# HOUSTON PLANNING COMMISSION

## AGENDA

MARCH 28, 2019

PROPOSED SITE PLAN

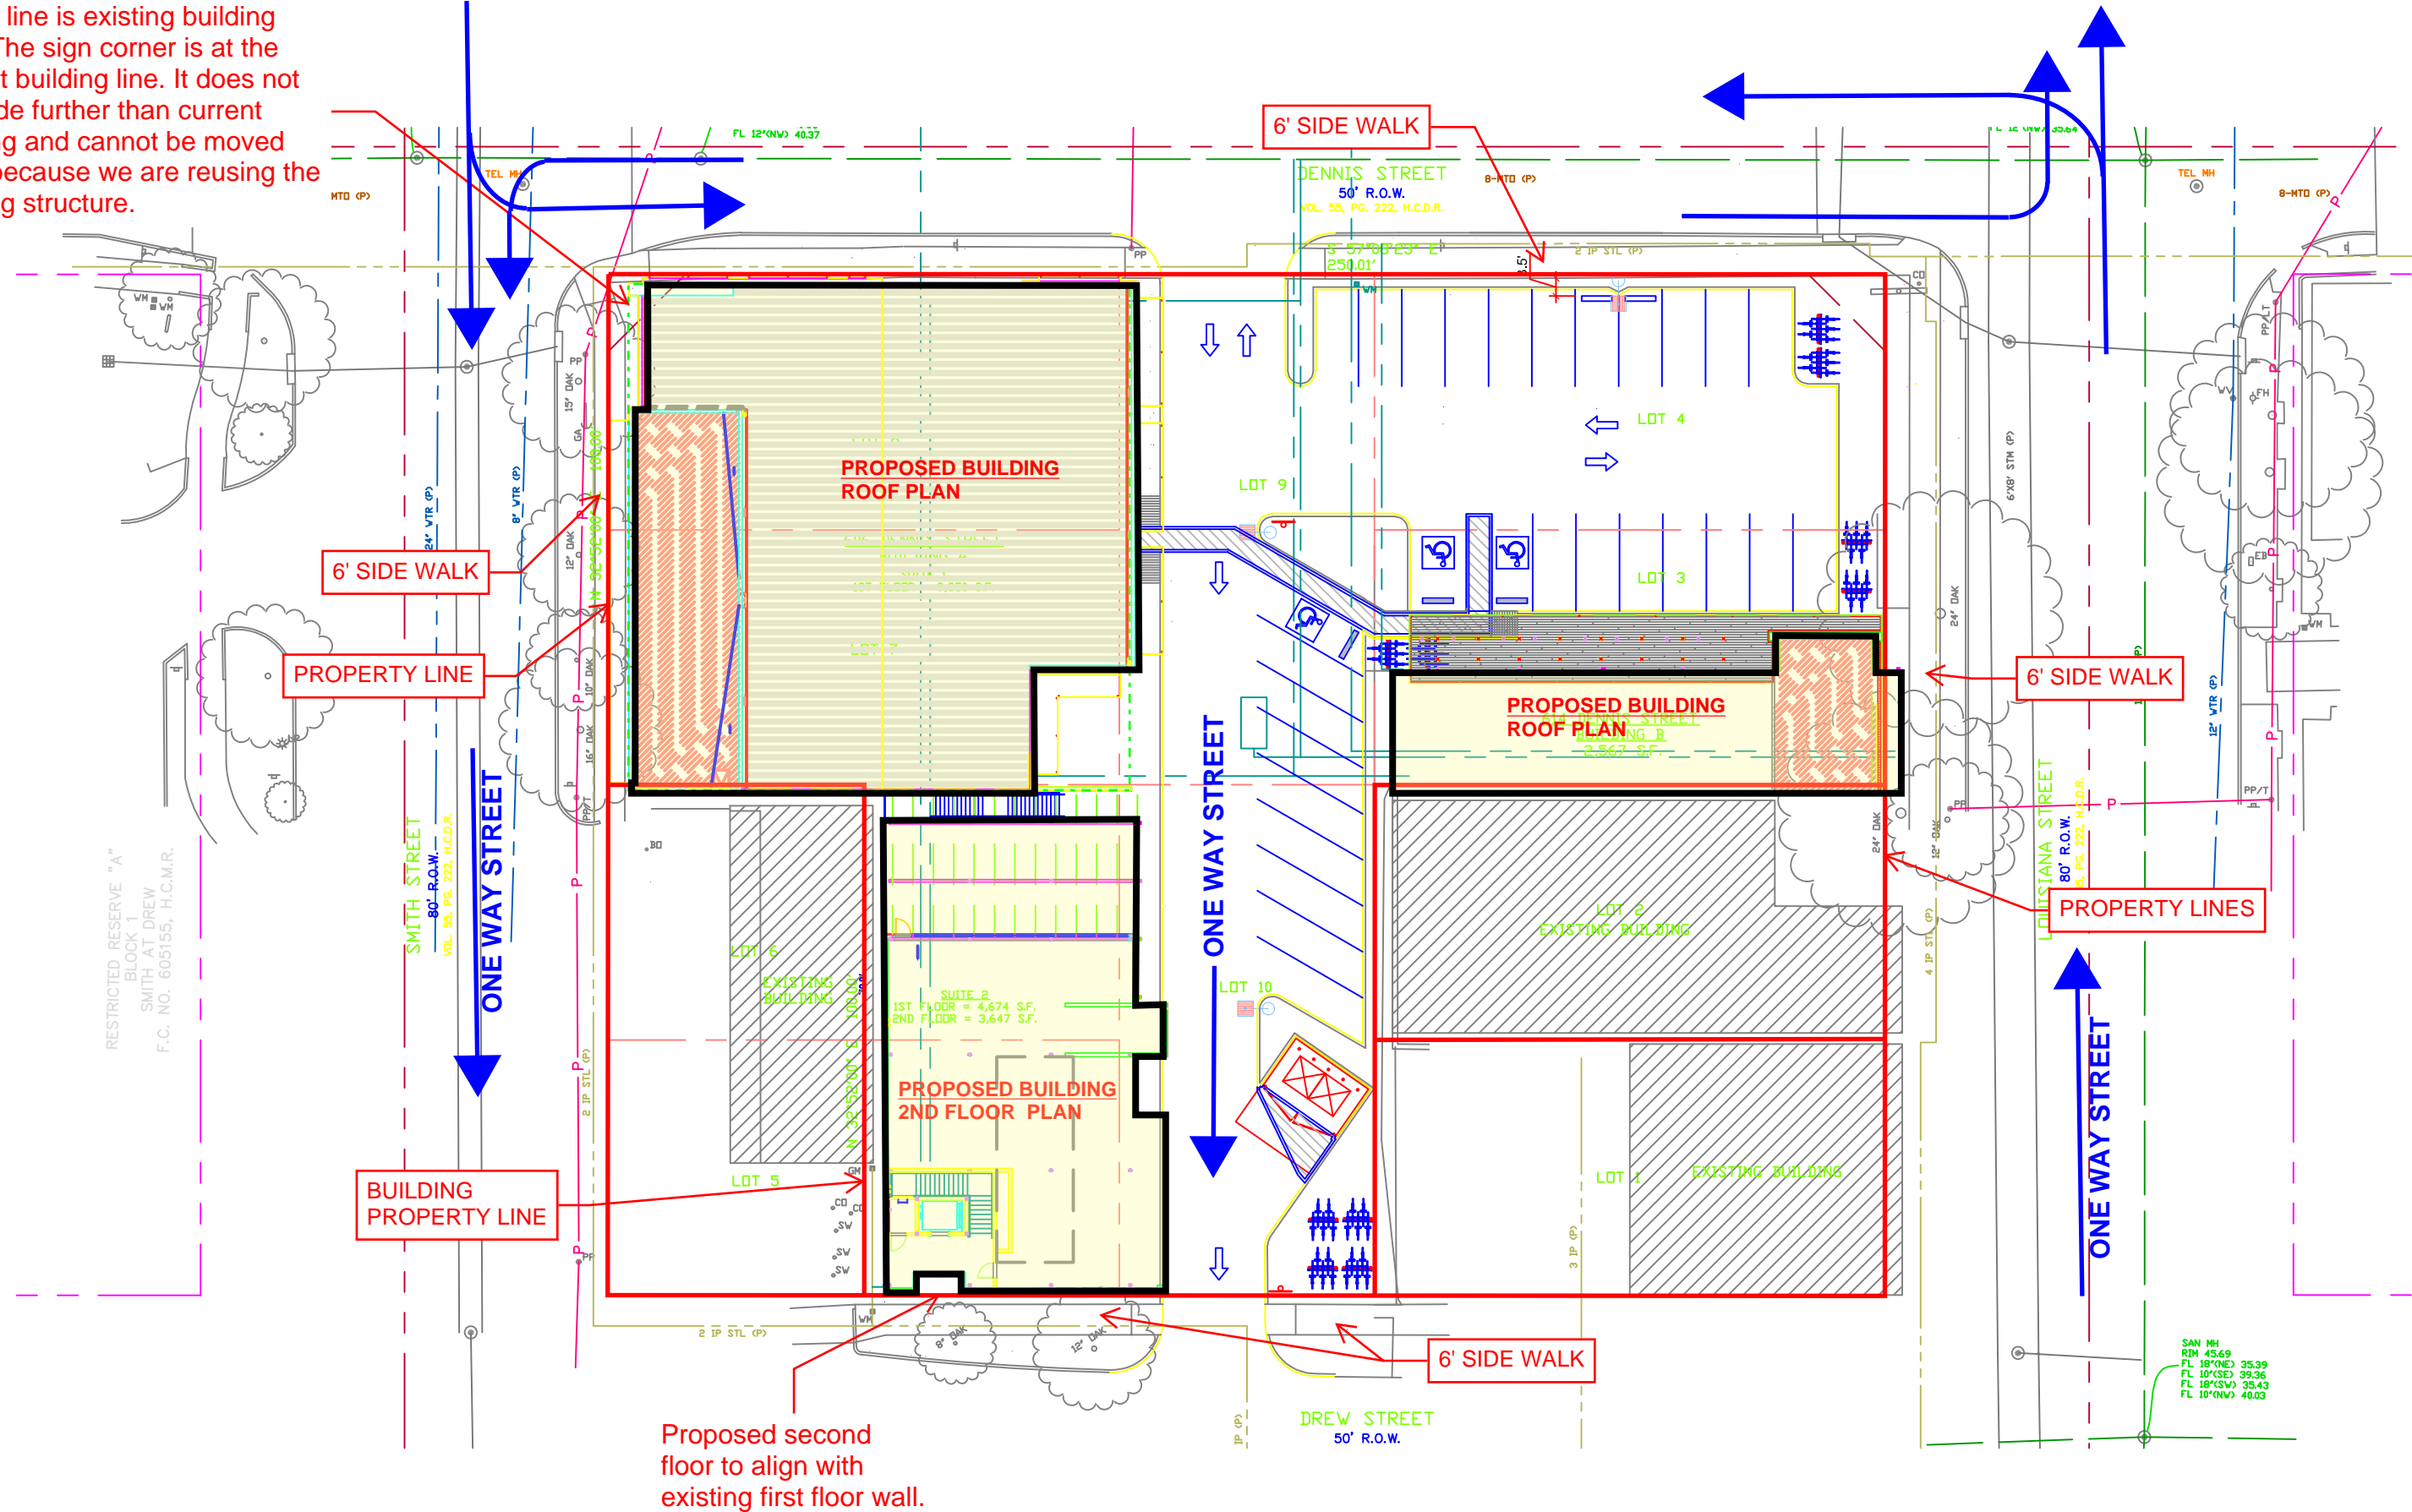
Green line is existing building line. The sign corner is at the current building line. It does not protrude further than current building and cannot be moved back because we are reusing the existing structure.
